From: William Kelly <William.Kelly@leics.gov.uk>
Sent: 03 February 2025 15:53
To: Laura Ashton
Cc: Planning Folder New
Subject: 24/00632/FUL | Highway Verge Hinckley Road / Desford Road Enderby
Attachments: Outline Construction Environmental Management Plan.pdf; Mitigation Area A.png; Mitigation Area C.png; Mitigation Area D Part 1.png; Mitigation Area E Part 1.png; Mitigation Area B.png; Mitigation Area D Part 2.png; Mitigation Area E Part 2.png

24/00632/FUL | Installation of an underground grid connection cable within the highway verge to connect Enderby Substation (Cross-boundary with Blaby District Council) | Highway Verge Hinckley Road / Desford Road Enderby

Archaeological considerations

T50-C3

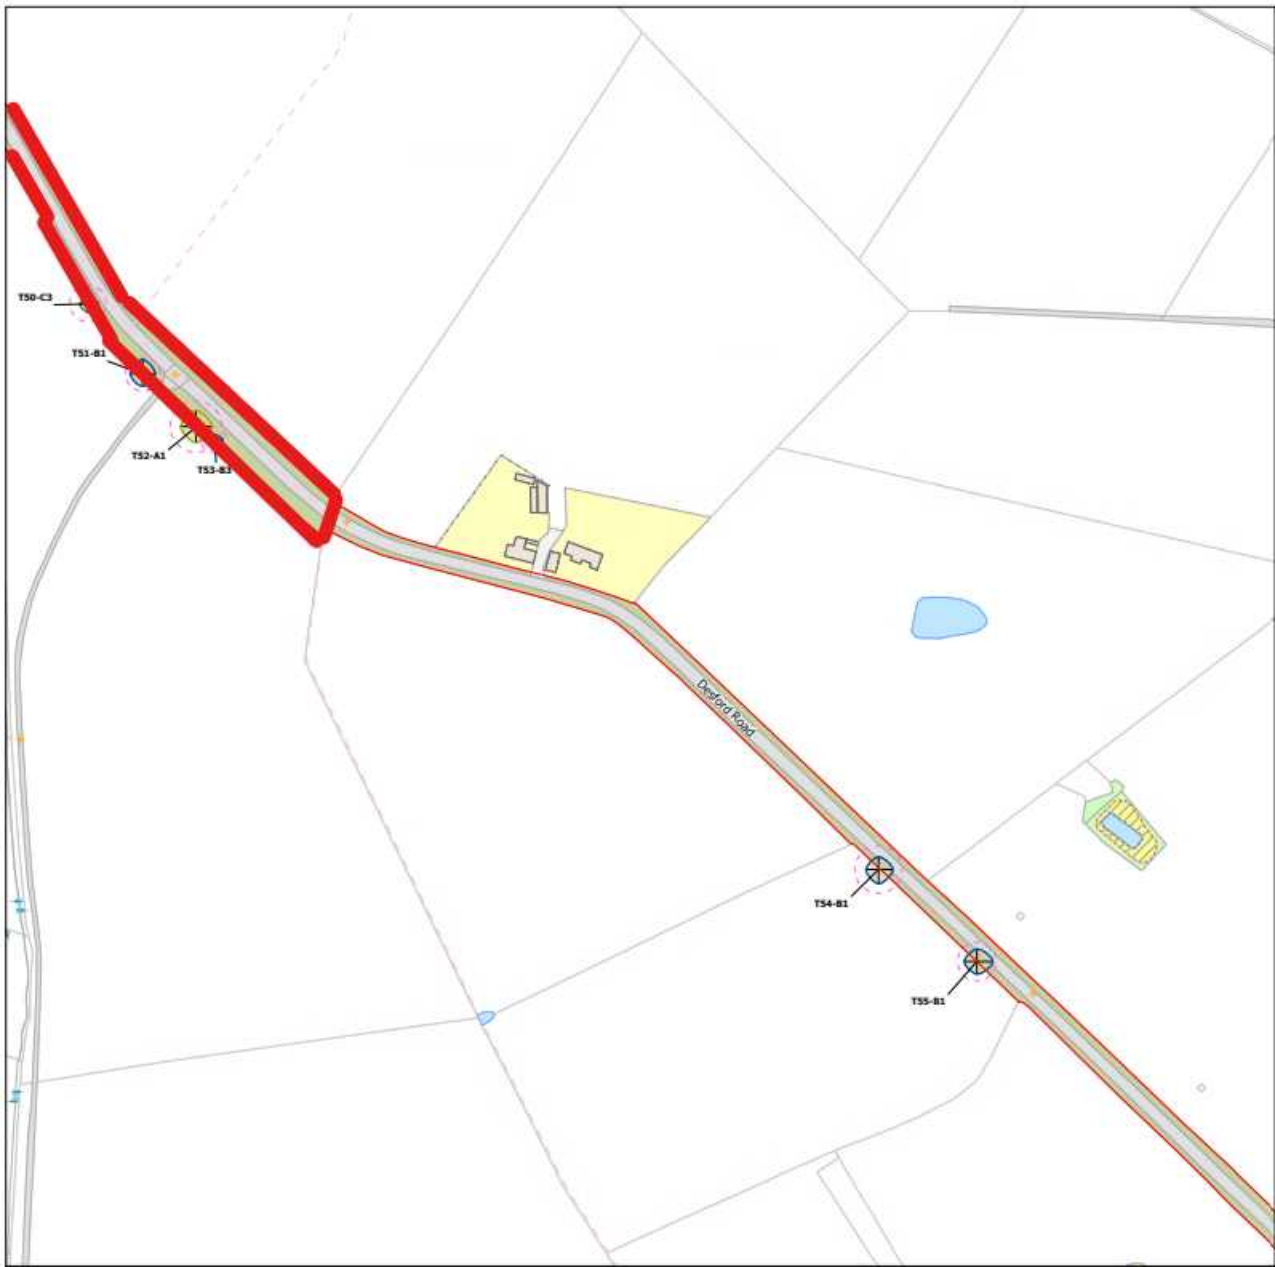
Please see the attached plans which illustrate the areas of known archaeological potential where a Strip, Plan and Record excavation should be undertaken; between Hill Farm solar farm and the A47 (Mitigation Area A); intersection of Dan's Lane/A47 (Mitigation Area B); intersection of the A47 within the Desford Cross Roads area (Mitigation Area C); area adjacent to Narborough Wood Cottage (Mitigation Area D); section of the route at Billsdon's Hollow

(Mitigation Area E). The applicant may also choose to undertake further exploratory trial trenching within these areas to refine the extent of the Strip, Plan and Record excavations.
